Modification in the
PIERHEAD AND BULKHEAD LINE
 for part of the
WEST SHORE OF ARTHUR KILL
 between
PILES AND MORSE CREEKS, N. J.
 recommended by the
NEW YORK HARBOR LINE BOARD

SEPTEMBER, 1908.

Copy
 War Department,
 October 8, 1908.

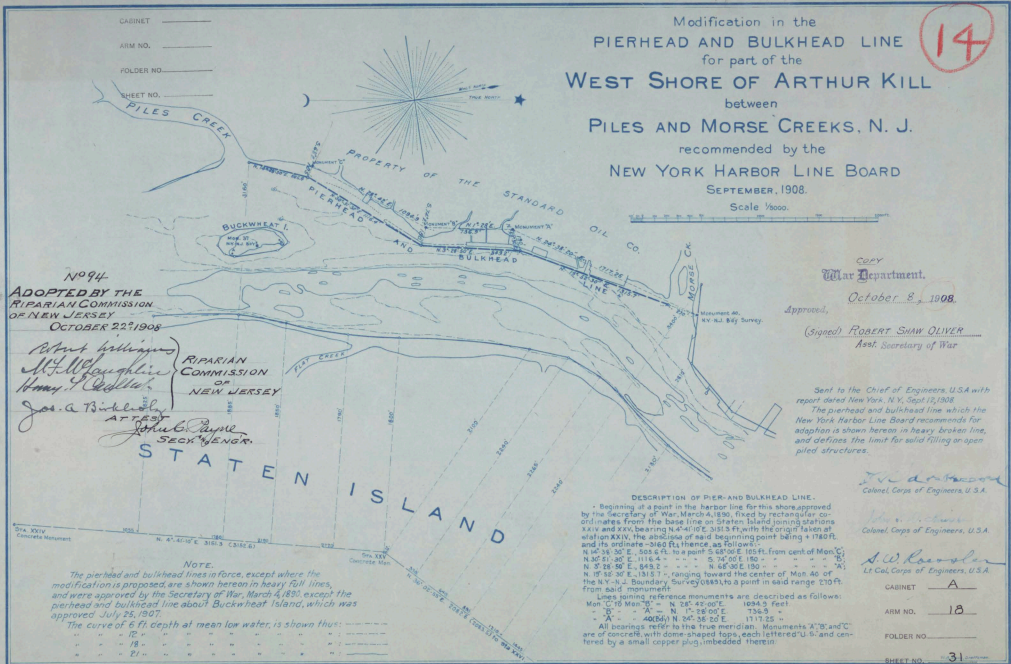
Sent to the Chief of Engineers, U.S.A with
 report dated New York, N.Y., Sept 12, 1908.
 The pierhead and bulkhead line which the
 New York Harbor Line Board recommends for
 adoption is shown hereon in heavy broken line,
 and defines the limit for solid filling or open
 piled structures.

DESCRIPTION OF PIER- AND BULKHEAD LINE.
 Beginning at a point in the harbor line for this shore approved by the Secretary of War, March 4, 1890, fixed by rectangular coordinates from the base line on Staten Island joining stations XXIV and XXV, bearing N 47° 41' 0" E, 3151.5 ft. with the origin taken at station XXIV, the abscissa of said beginning point being +1780 ft. and its ordinate -3160 ft. thence, as follows:
 N 46° 35' 30" E, 505.6 ft. to a point 5 68° 00' E 165 ft. from cent of Man C.
 N 30° 31' 30" E, 1116.4 " " " 5 74° 00' E 180 " " " B.
 N 3° 38' 30" E, 849.2 " " " N 46° 30' E 180 " " " A.
 N 18° 15' 30" E, 1315.7 " " " ranging toward the center of Man A. of the N.Y.-N.J. Boundary Survey (1885), to a point in said range 130 ft. from said monument.
